ANSTY GARDEN COMMUNITY,

DESIGNERS RESPONSE

REPORT REF NO. 2207280-R15B

- 1.4 The Audit was undertaken on the proposed A272 Southern Access roundabout junction, which is located to the south of the proposed development site. The works involve the construction of a new roundabout and pedestrian/cycle infrastructure improvements to include new crossing facilities.

AO Scale: 1:500 Date: 22.02.23 Designed by: DV
 Drawn by: DV Checked by: DV Approved by: DH
 Drawing Number: 2207280-005 Rev: C

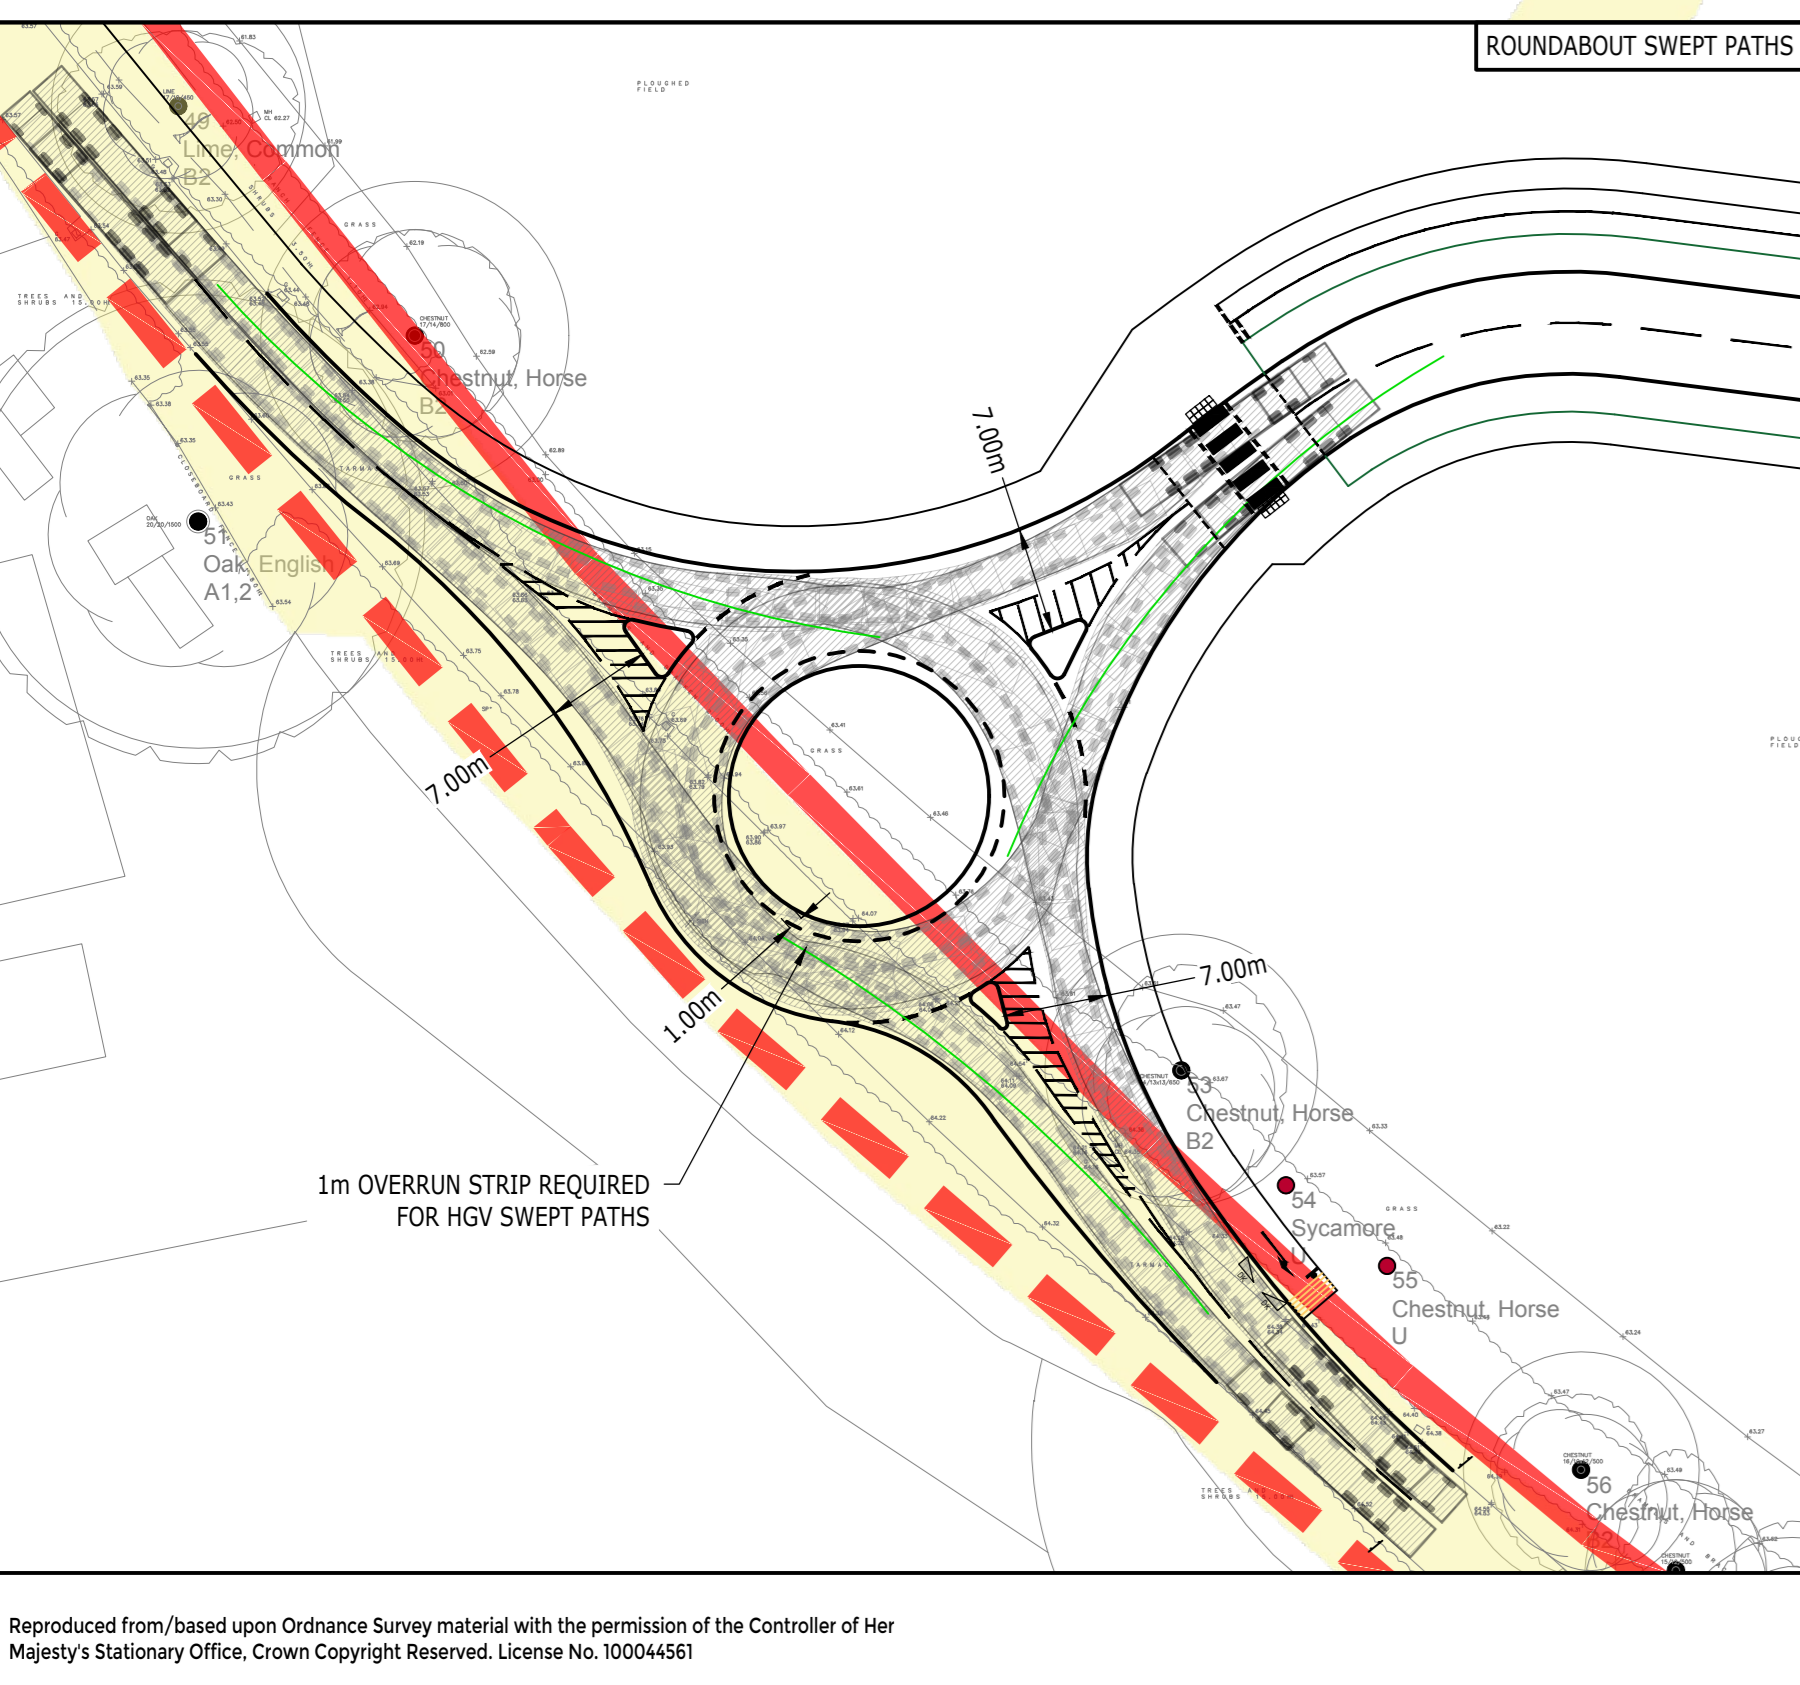
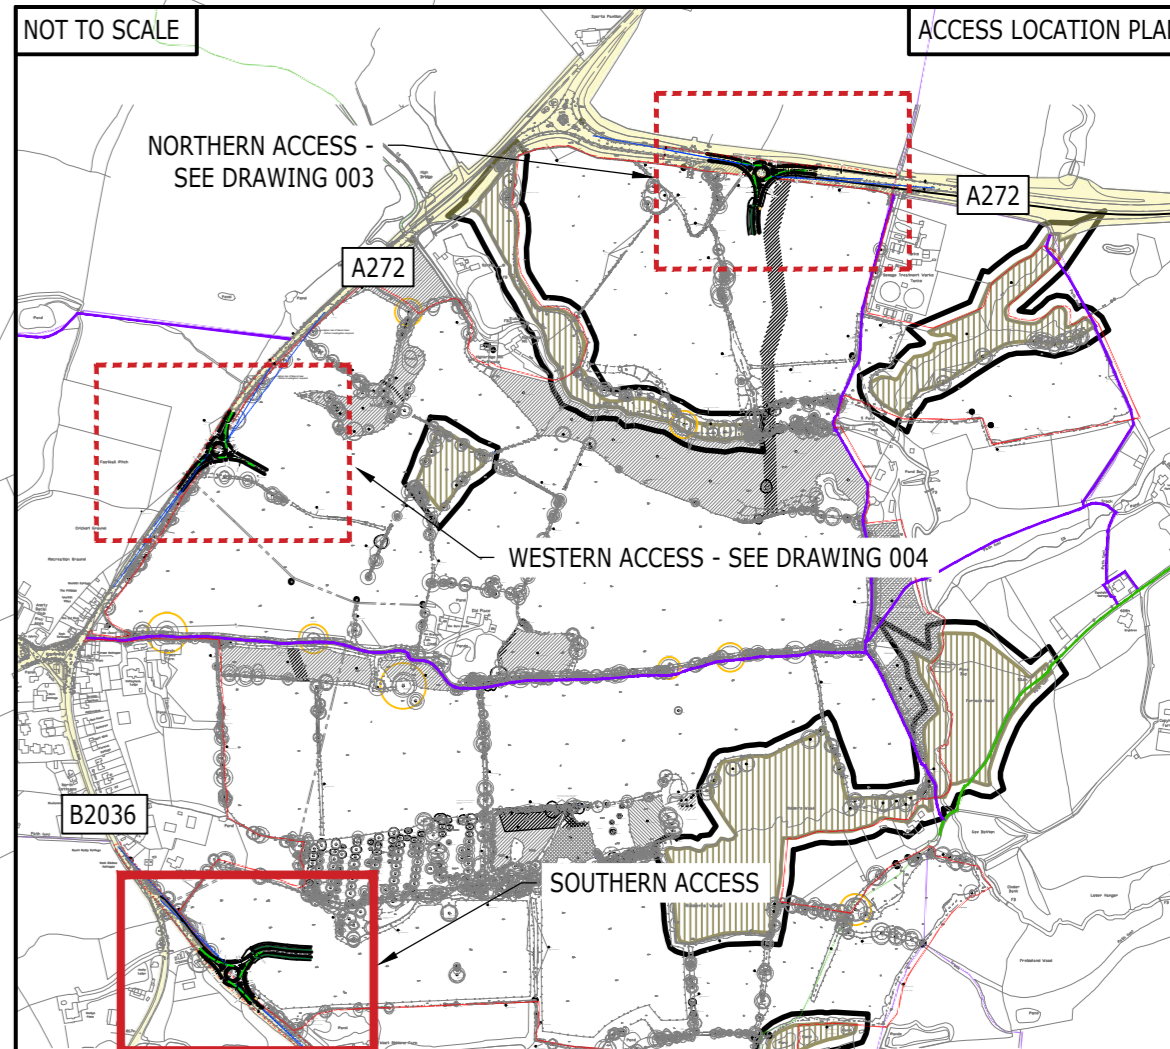
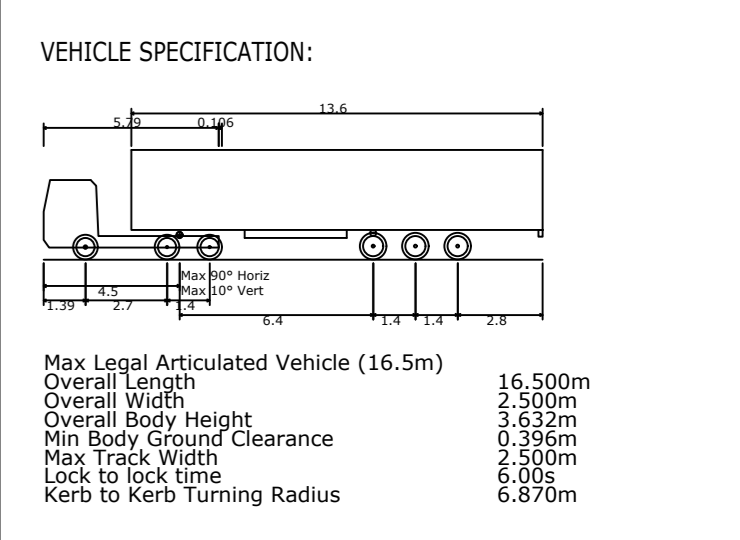
3.1.1 PROBLEM

Summary: Insufficient construction details could lead to overshoot or rear end shunt collisions.

The proposals do not include the introduction of anti-skid surfacing or detail the Polished Stone Value (PSV) to be used on the approaches to the roundabout and surfacing as part of the scheme. Surfacing with an insufficient PSV could lead to overshoot or rear end shunt collisions.

It is recommended that high friction surfacing should be provided on all the approaches to the roundabout and that the PSV of all surfacing should be provided for assessment a Stage 2 Safety Audit.

3.1.2 PROBLEM

Summary: Ponding of surface water could lead to loss of control collisions.

Kerblines are being amended as part of these proposals, where no details of carriageway drainage have been provided for assessment; ponding on the carriageway or water moving across the carriageway at junctions or bends could lead to loss of control collisions, particularly in wet / icy conditions.

It is recommended that drainage details should be provided at Stage 2 Safety Audit.

3.1.3 PROBLEM

Summary: Insufficient signing could lead to could lead to vehicle to pedestrian / cyclist collisions or rear end shunts.

A national speed limit currently applies to this section of Harvest Hill, where the proposed speed limit on the eastern arm is unknown. This could lead to inappropriate vehicle speeds approaching the Parallel crossing, which should not be installed on roads with an 85th percentile speed of 35 mph or above without speed reducing measures to slow traffic.

It is recommended that a 30mph speed restriction should be applied to the eastern arm of the roundabout.

3.1.4 PROBLEM

It is recommended that antiskid surfacing or surfacing with a high PSV should be used on the approaches to the crossing.

3.2.1 PROBLEM

Stopping Sight Distances (SSD) have been provided for assessment and at 215m are acceptable for the current national speed limit. An insufficient SSD may increase the risk of junction related or shunt type collisions at the roundabout and so the 120m SSD, which is commensurate with a 40mph design speed, should only be incorporated if a reduced speed limit of 40mph is introduced.

It is recommended that the SSD should be commensurate with the design speeds.

3.2.2 PROBLEM

On the westbound approach to the roundabout no SSD has been provided for assessment. There is concern that the SSD could pass over non-highway land. Vegetation or landscaping features in this splay could restrict visibility, where insufficient visibility may increase the risk of junction related or shunt type collisions at the roundabout.

It is recommended that the SSD should be supplied for assessment and that they should be within the adoptable highway, or that a suitable covenant should be arranged to ensure that the splay is not affected by planting or landscaping features.

3.2.3 PROBLEM

The proposed roundabout is located on Harvest Hill, where there is a fall from the northwest to the southeast. At this early stage no vertical alignment details were provided for assessment. There is concern that inappropriate vertical profiles could restrict visibility at the junction, which may lead to side impact collisions and loss of control collisions.

It is recommended that vertical alignment details should be provided for assessment at Stage 2 Safety Audit.

3.2.4 PROBLEM

On the westbound approach to the Parallel crossing no SSD has been provided for assessment. There is concern that the SSD could pass over non-highway land. Vegetation or landscaping features in this splay could restrict visibility, where restricted SSD may increase the risk of vehicle to pedestrian / cyclist collisions or rear end shunts.

It is recommended that the SSD should be supplied for assessment and that they should be within the adoptable highway, or that a suitable covenant should be arranged to ensure that the splay is not affected by planting or landscaping features.

3.3.1 PROBLEM

No details of expected flows and the capacity of the roundabout have been provided for assessment. Insufficient capacity could lead to congestion where excessive queuing at the roundabout could lead to driver frustration and the use of inappropriate gaps, further unbalanced flows could lead to entry problems on to the roundabout. This may lead to rear end shunt or side impact collisions.

It is recommended that the roundabout should operate without excessive queuing and with balanced flows and that an ARCADY or similar model should be provided for assessment.

3.5.1 PROBLEM

At this early stage no details of street lighting have been provided for assessment. A lack of lighting could increase the risk of loss of control and side impact collisions at the roundabout and vehicle to pedestrian / cyclist collisions during the hours of darkness.

It is recommended that street lighting should be checked with the Highway Authority's street lighting team and that a plan showing the light distribution should be provided for assessment at Stage 2 Safety Audit.

3.5.2 **PROBLEM**

At this early-stage full details of road markings have not been provided for assessment, including the Controlled Area. A lack of a Controlled Area could lead to inappropriate parking near the crossing that may restrict intervisibility, increasing the risk of vehicle to pedestrian / cyclist collisions.

It is recommended that the Controlled Area should be provided for assessment at Stage 2 Safety Audit.

- 3.1.1 Noted and accepted.
- 3.1.2 Noted and accepted.
- 3.1.3 Noted and accepted.
- 3.1.4 Noted and accepted.
- 3.2.1 Noted and accepted.
- 3.2.2 Noted and accepted.
- 3.2.3 Noted and accepted.
- 3.2.4 Noted and accepted.
- 3.3.1 Noted and accepted.
- 3.5.1 Noted and accepted.
- 3.5.2 Noted and accepted.
